ADDENDUM #05

Project Name: Central County Fire & Rescue – HQ, Training, Maintenance

Project Number: 23121

Date: October 28, 2025

Project No.
23121
 Sheet No.
E241
 Date
09/16/2025

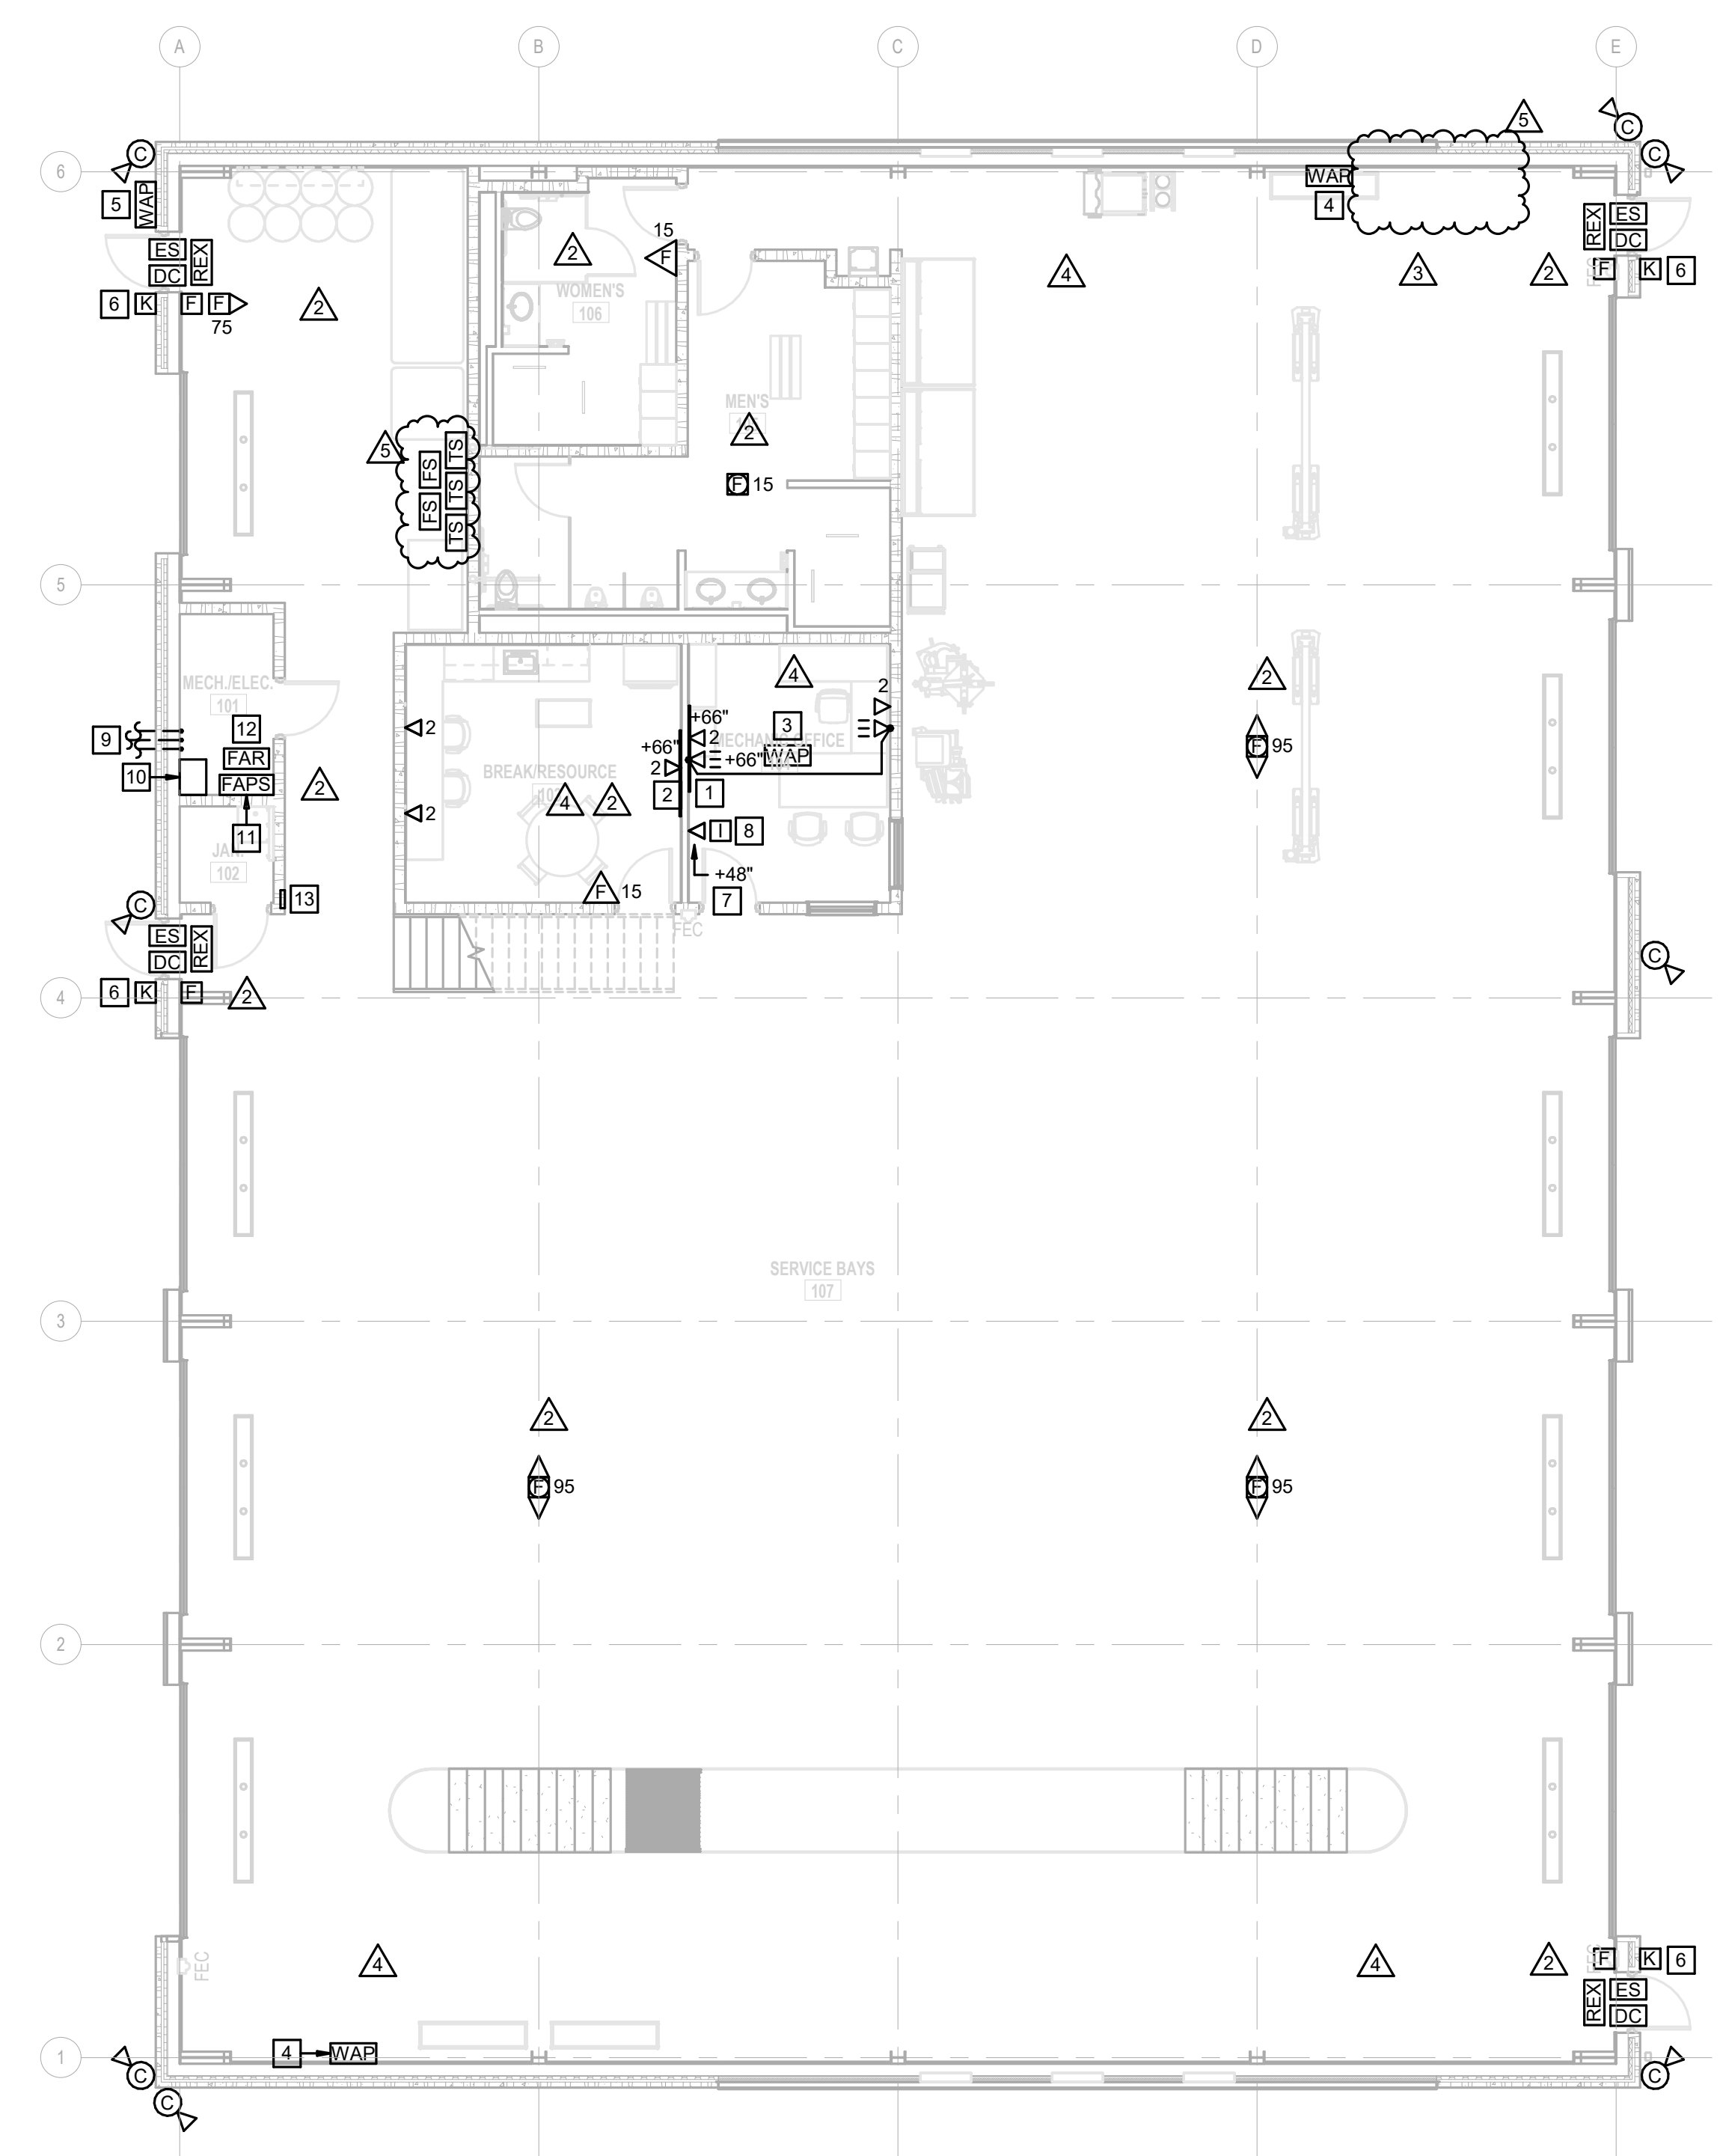
1. Sheet E221 – Maintenance Power Plan
 - a. **Modified keyed notes 4, 5, and 19.**
 - b. **Relocated location of fan controllers and shown 4 separate controllers.**
 - c. **Reference attached Revised Sheet.**
2. Sheet E241 – Maintenance Auxiliary Plan
 - a. **Moved the FA tamper and flow switches from Apparatus Bay to the fluids room.**
